DA NO: DA-2018/266

ADDRESS: 16 THE BATTLEMENT, CASTLECRAG NSW 2068.

PROPOSAL: CONSTRUCTION OF A NEW DWELLING, SWIMMING POOL AND ASSOCIATED WORKS.

MEETING DATE 24 SEPTEMBER 2019

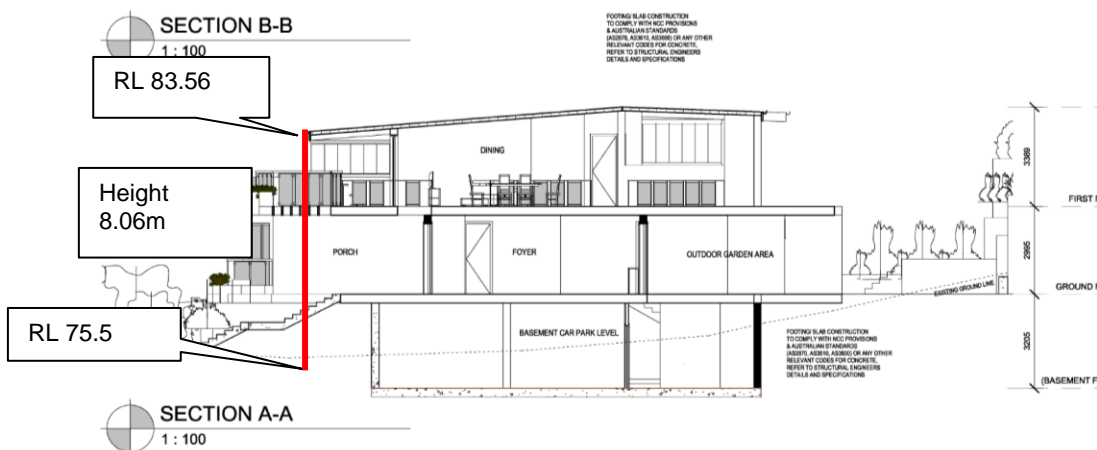
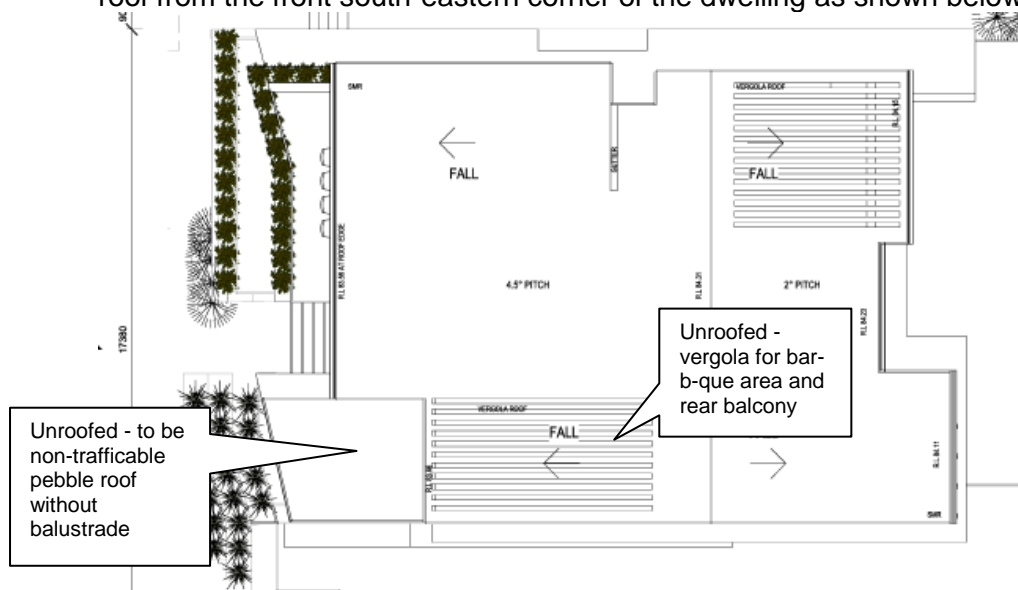
The changes requested to the plans reduce the height of the building by a maximum of 1.43m:

Original Plans

Final Amended Proposal

Note: height to be 8m by condition – a reduction of 60mm.

The RL at the front elevation of the roof is shown on the roof plan to be RL 83.56. It is a recommended condition of consent that the RL for the roof at the front elevation does not exceed a height of RL 83.5,

14 The Battlement

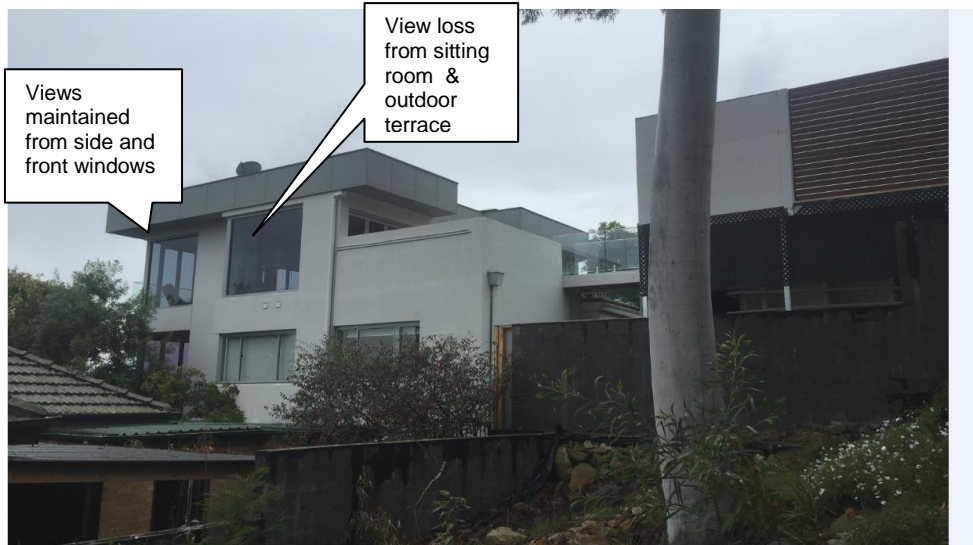
A view corridor to Middle Harbour from the pool and pool deck area will be maintained as it extends over 14 The Battlement. The height of the side boundary fence adjoining the pool at 14 The Battlement is RL83.6 which is higher than the proposed height of the roof at the front elevation RL 83.5.

Views from the side facing bedroom windows at the ground floor will be lost as the windows have sill heights of RL 79.8 and head heights of RL 81.3 and will be adjacent to the proposed dwelling house at 16 The Battlement.
